PCN – Process Change Notification

Change:	CAB.628
Date:	2018/03/27
Author	Haley Tsai

Model#	Part Number	Changes
IPEX MHFI to RP-SMA(F)BKST. 95mm 1.13 cable	CAB.628	<ol style="list-style-type: none"> 1. Tolerance of the heat shrink tube is not the critical check point, so we will remove $\pm 5\text{mm}$. 2. Dimension of the connector pin is not the critical check points, so we will remove $\text{Ø}0.95\text{mm}$. 3. According to IPEX connector drawing, we will amend the following tolerances. Amend $3\pm 0.3\text{mm}$ to $3\pm 0.2\text{mm}$. Amend $2.1\pm 0.3\text{mm}$ to $3\pm 0.2\text{mm}$. Amend $5.2\pm 0.6\text{mm}$ to $3\pm 0.5\text{mm}$.

**Illustration of Change
Old Drawing**

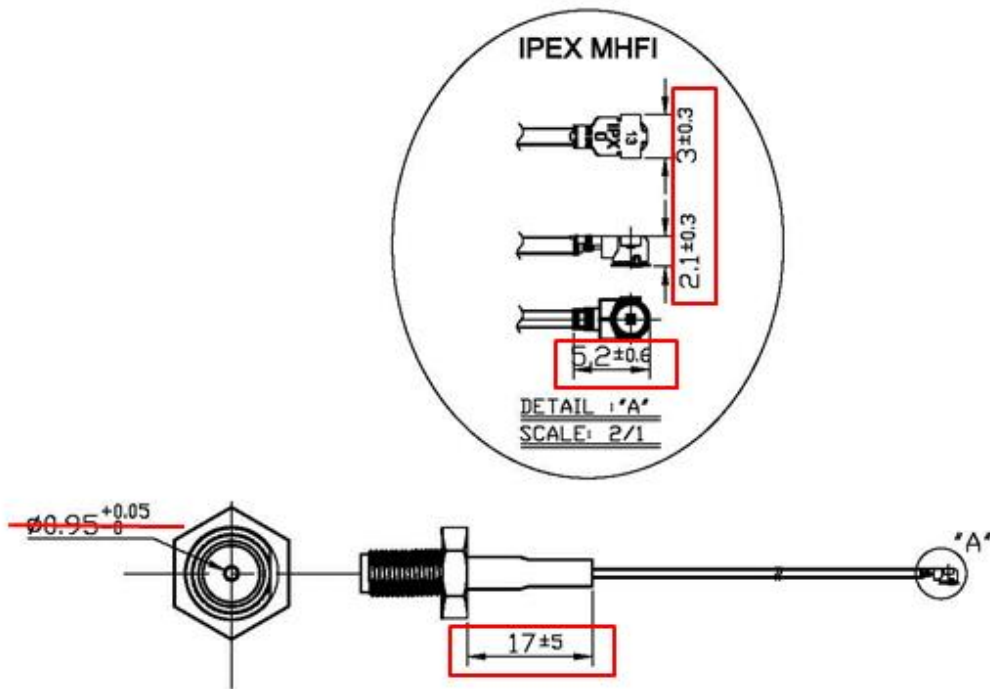
1. Tolerance of the heat shrink tube is not the critical check point, so we will remove $\pm 5\text{mm}$.
2. Dimension of the connector pin is not the critical check points, so we will remove $\text{Ø}0.95\text{mm}$.
3. According to IPEX connector drawing, we will amend the following tolerances.
Amend $3\pm 0.3\text{mm}$ to $3\pm 0.2\text{mm}$.
Amend $2.1\pm 0.3\text{mm}$ to $3\pm 0.2\text{mm}$.
